Response to Submissions and Further Amended Concept Proposal

Redevelopment of Harbourside Shopping Centre
Darling Harbour

Submitted to NSW Department of Planning,
Industry and Environment

On behalf of Mirvac Projects Pty Ltd

Figure 6 Proposed refinements and improvements to the podium

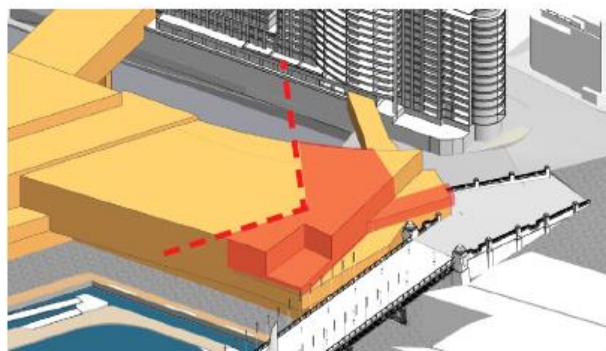
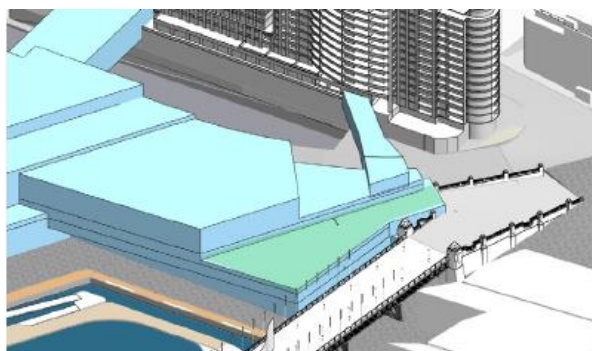
Commentary on the relocation of the residential tower to the centre of the site under the previous RtS response package was generally very favourable as being a significant improvement, and supported by the Department, the Independent Urban Design Review, the City of Sydney and some surrounding residents. The City of Sydney also expressed the sentiment that the podium height should be lowered with an increased setback at the north of the site to improve sightlines to the existing stairs adjacent to Pyrmont Bridge along with concerns the tower envelope footprint is excessive.

A significant number of submissions from the general public and community groups expressed views that the height and/or bulk of the residential tower, and/or the podium component is excessive. This included perceptions that the height of the development is excessive for a site by the waterfront, and that it is not commensurate with the surrounding built form and/or 'open' nature of Darling Harbour. A key themes raised by residents, mainly within 50 Murray Street, is that the height of the podium should be consistent with the height of the existing building.

2.1.2 Proponent's response

Figure 23 Illustration of 50 Murray Street view improvements

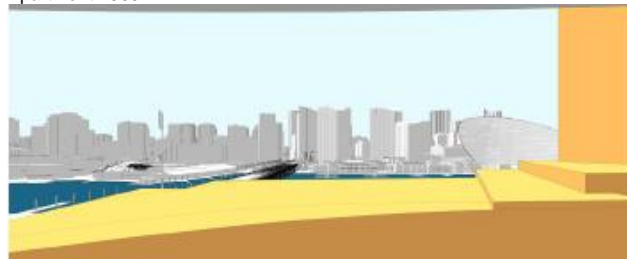
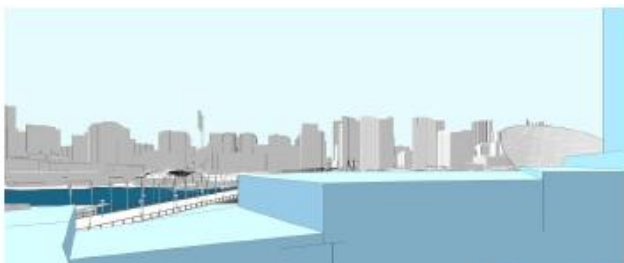
Ensuring that the view impacts of the proposed development on 50 Murray Street (One Darling Harbour) are minimised has been a significant priority throughout the design process of the proposed development. Evidence of the exhaustive steps and substantive improvements Mirvac have made along the planning process in order to minimise view impacts to 50 Murray Street is clearly evident in the series of diagrams below (refer to page 24 of the Supplementary Architectural Design Report at **Appendix D** also). Mirvac have reached a point now where the tower has been moved as far south as possible and the northern podium has been lowered as much as possible.

The below images, which have been prepared purely for illustration purposes and have not been relied upon in the assessment of view impacts within the Visual and View impact Analysis included at **Appendix E**, provide an indication of the degree of improved views experienced from some select apartments within 50 Murray Street between the amended concept proposal and the further amended concept proposal. Improvements to views include more expansive views to higher value features such as Cockle Bay and Pyrmont Bridge.

Figure 30 Sydney LEP 2012 Parking Categories Map (Harbourside in red)

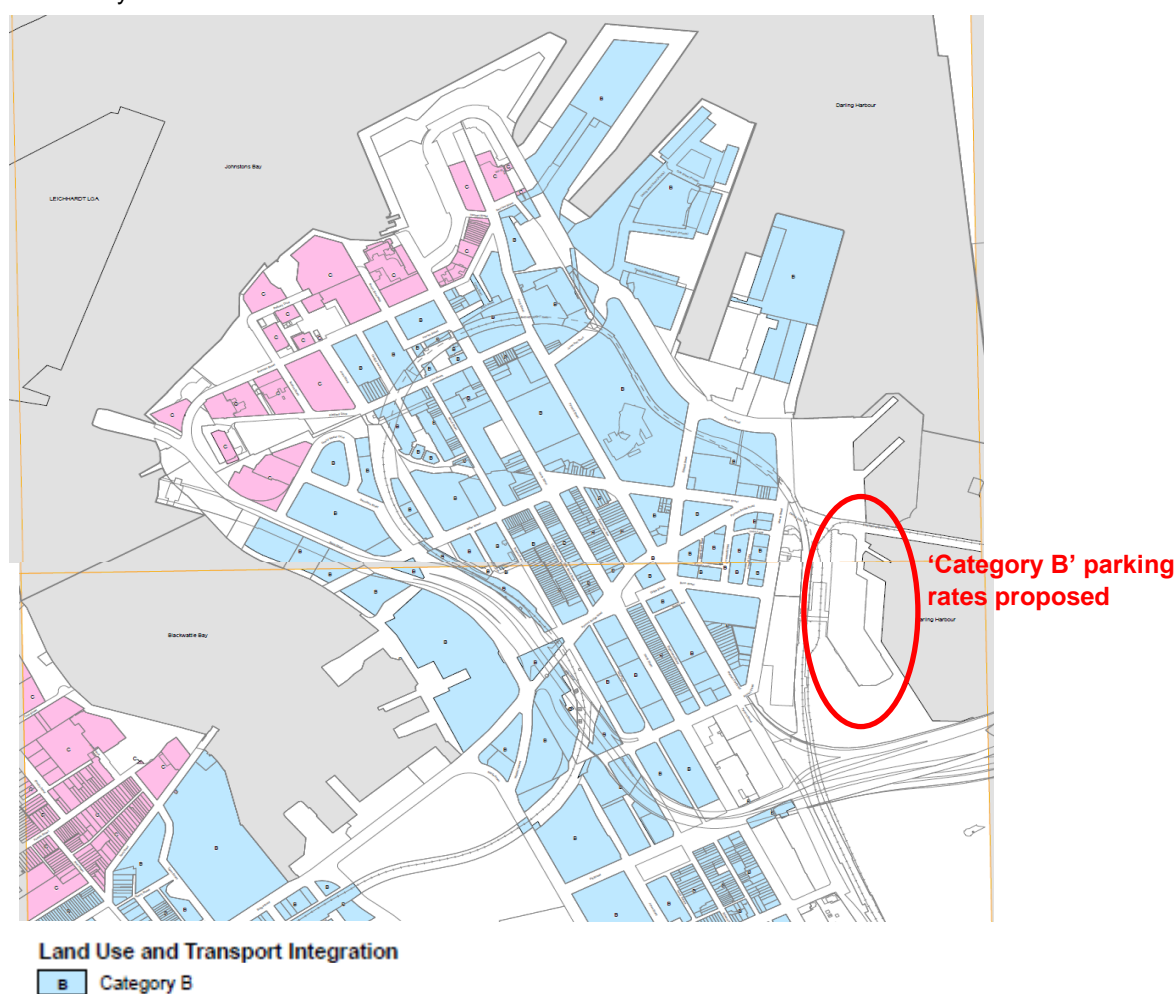
The City of Sydney submission overall claimed the Traffic and Transport Report to be deficient, raising concerns with vehicle queuing to Darling Drive, inadequate servicing arrangements, unsatisfactory consideration of traffic generation impacts, inadequate consideration of bicycle infrastructure and facilities, and insufficient detail to determine whether pedestrian links will have adequate capacity and amenity.

When applying the equivalent LEP parking rates to the proposed apartment mix within the indicative design scheme Arcadis confirm there would be a maximum of 285 spaces to be provided and allocated for the residential apartments (with the balance of allowable spaces up to 306 allocated for car share and visitors). This figure equates to 0.79 spaces per dwelling. Arcadis has undertaken additional analysis of existing car ownership in order to provide additional validity to the proposed parking rate. The results of which confirm that for the surrounding areas of Pyrmont, Ultimo, and Sydney, that approx. 90%, 87% and 71% respectively of dwellings with higher annual incomes (being equivalent to the expected owner/tenant profile of dwellings at Harbourside), own one or more motor vehicles. This reveals that there is a strong reliance on most dwellings within the surrounding areas having at least one car for their transport needs.

Overall, the right balance is considered to be achieved with the proposed parking rates that acknowledges the site has access to good public transport, but also reflects market demands and the existing level of car ownership within the locality.
